**Amendments to the classification of desensitized explosives
according to the GHS**

**Transmitted by the experts from Germany and the United States of
America**

This informal document contains the clean version of the text of Chapter 2.17 of the GHS and Section 51 of the Manual of Tests and Criteria as amended in accordance with the proposals listed in document ST/SG/AC.10/C.3/2022/50- ST/SG/AC.10/C.4/2022/10. Please note that the following paragraphs remain unchanged: 2.17.24, 2.17.3, 2.17.4, 2.17.4.2, 2.17.4.21 and 2.17.4.2.2.

Amended version of Chapter 2.17 of the GHS (clean version)

Decision logic 2.17.1 for desensitized explosives

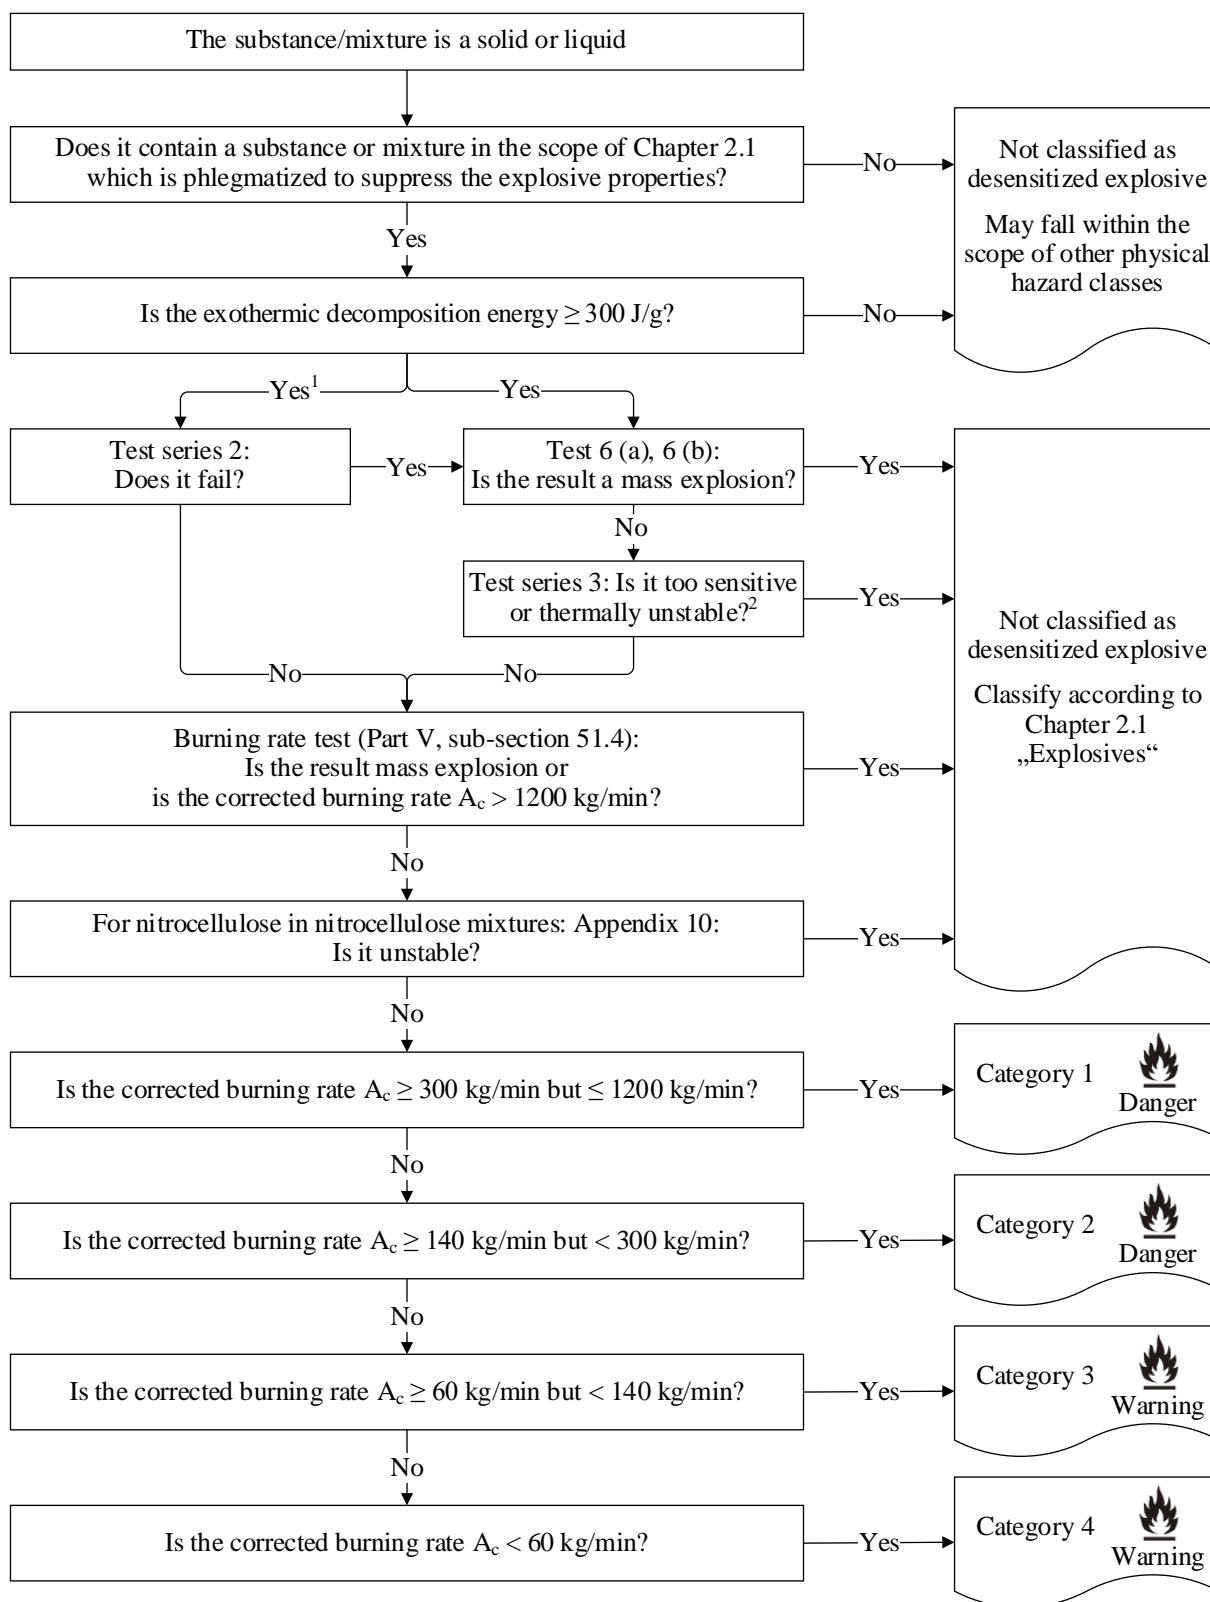
To classify desensitized explosives, data for the sensitivity, thermal stability, explosive potential and the corrected burning rate should be determined as described in Part I and Part V of the *Manual of Tests and Criteria*. For nitrocellulose, additional data for the stability as described in Appendix 10 of the *Manual of Tests and Criteria* are needed in order to be used in nitrocellulose mixtures considered for this class. Classification is according to decision logic 2.17.1.

¹ Test series 2 is optional. The alternative route (via test 6 (a) and (b) and test series 3) may be taken directly without performing test series 2.

² Test series 3 is not applicable to nitrocellulose mixtures containing no other explosives than nitrocellulose.
